## DEPARTMENT OF TRANSPORT

Airworthiness Directive - Gliders

Reference GFA/Start & Flug  
2/74.

Subject Modification to canopy locking mechanism for  
improved operating security.

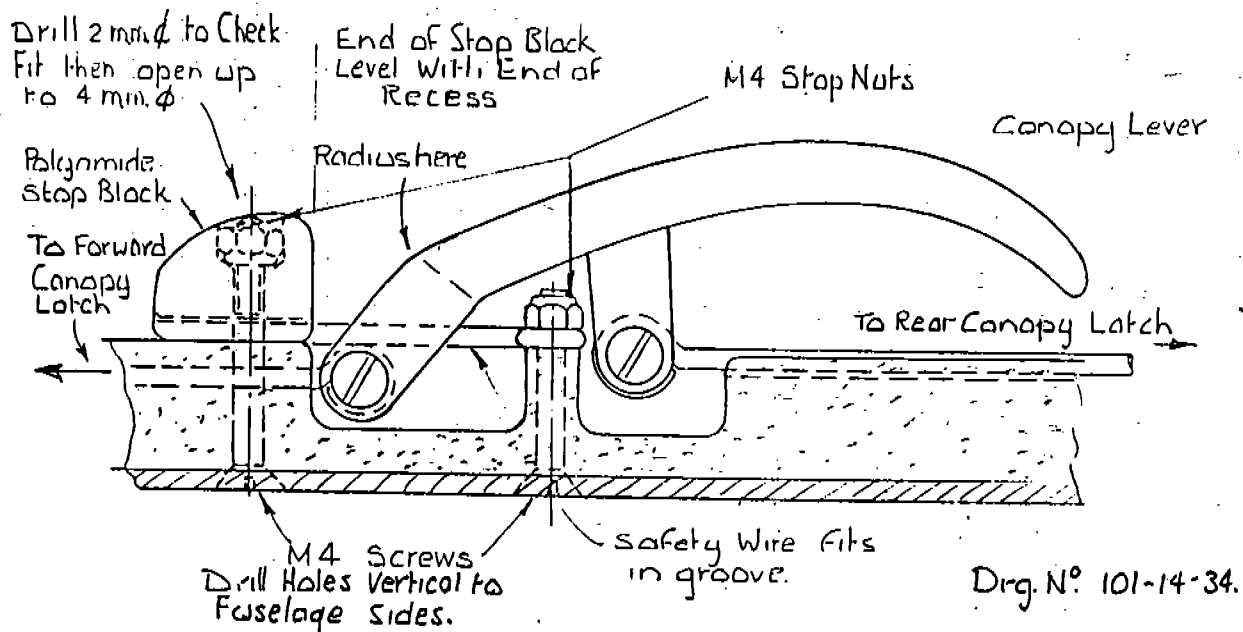
Polyamide (Nylon) stop blocks are to be added to both canopy fastening mechanisms as shown on Dwg. No. GFA/Start & Flug 2/74-101-14-34. Parts are supplied by Australian Distributor, E. Schneider Pty. Ltd.

The modification is to be carried out before any aerobatic manoeuvres are carried out and for operation in Normal Category before 30th September, 1974. Compliance is mandatory.
